Intel[®] Pentium[®] II Xeon[™] Processor Specification Update

Release Date: September 2000

Order Number: 243776-024

The Pentium[®] II Xeon processor may contain design defects or errors known as errata which may cause the product to deviate from published specifications. Current characterized errata are documented in this Specification Update.

Figure 1. An Example of Microcontroller Driven Thermal Management

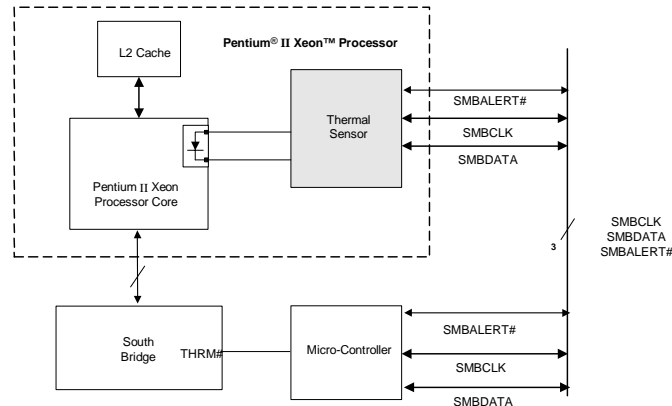
D30. Thermal Sensor May Assert SMBALERT# Incorrectly

Problem: The Pentium II Xeon processor has a thermal sensor that monitors the processor core's temperature. The thermal sensor asserts SMBALERT# if the processor temperature exceeds the temperature limits set in the Alarm Threshold Registers (T_{HIGH} , T_{LOW}). It also sets the corresponding Status Register bits to identify the cause of the interrupt. Figure 1 gives one example of the how the SMBALERT# signal could be used in a system.

Under the conditions described below, the thermal sensor incorrectly generates the SMBALERT# interrupt. All of the following conditions must be met to trigger a false interrupt:

Workaround: Three different (mutually exclusive) workarounds are possible:

1. Before servicing an interrupt from the thermal sensor, read and compare the processor thermal reading with the threshold limits (T_{HIGH} or T_{LOW}). Figures 2 and 3 provide basic flowcharts for the implementation of this workaround in an interrupt driven system.
2. If the firmware implemented polls the Status Register only, then before taking any action, re-read the temperature register and do a comparison with the alarm threshold limits (T_{HIGH} or T_{LOW}) to determine if the value is actually still within the temperature window.
3. Use a temperature polling scheme to monitor the processor temperature
